Subject: Consultation Window Open for ACP-2021-078 Enabling Remotely Piloted Aircraft Operations from RAF Fairford - HALE

Consultation Feedback Response

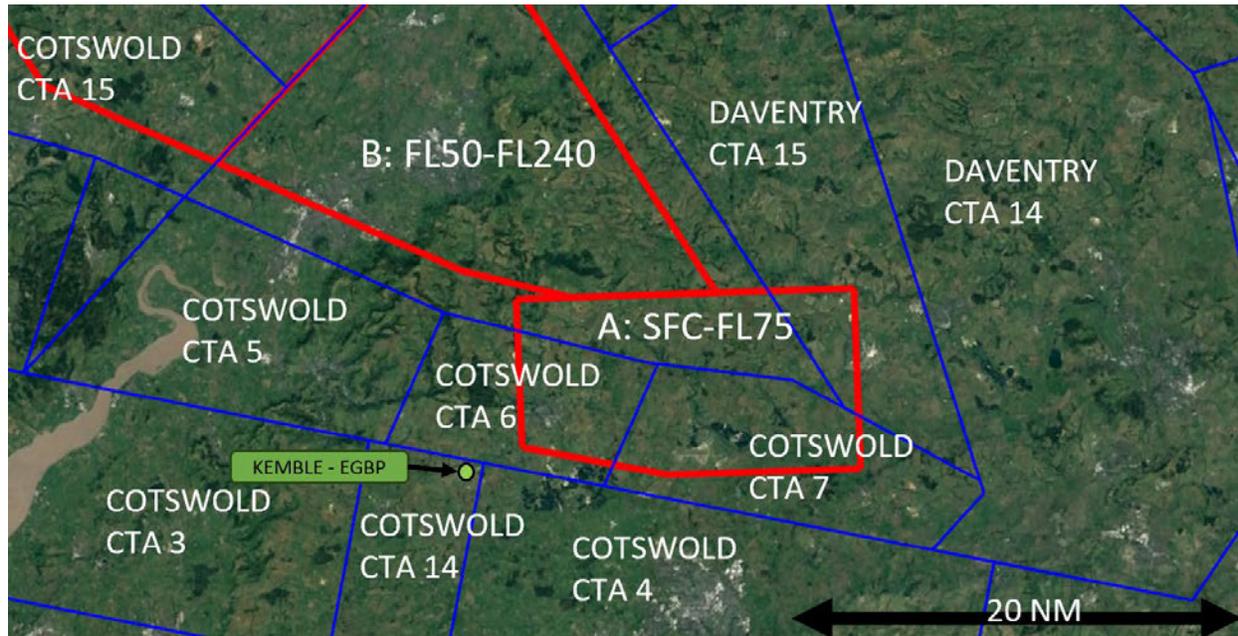
That's great, thanks for the reply. Is that drawing available as an aviation chart which will show the airspace in a bit more detail???

Please can you expand on the area that involves Kemble (EGBP)? The drawing on the proposal isn't very clear and a little more detail in a higher resolution picture of the map would be useful.

Thank you for your question. Please see the included image of the proposed Danger Area (Option 3) in relation to Kemble. The approximate location of Kemble was added to the map on page 14 of the Consultation Document. It appears as if the closest portion of the proposed airspace is ~2.69 NM from the airport and ~2.27 NM from the threshold of RWY 26.
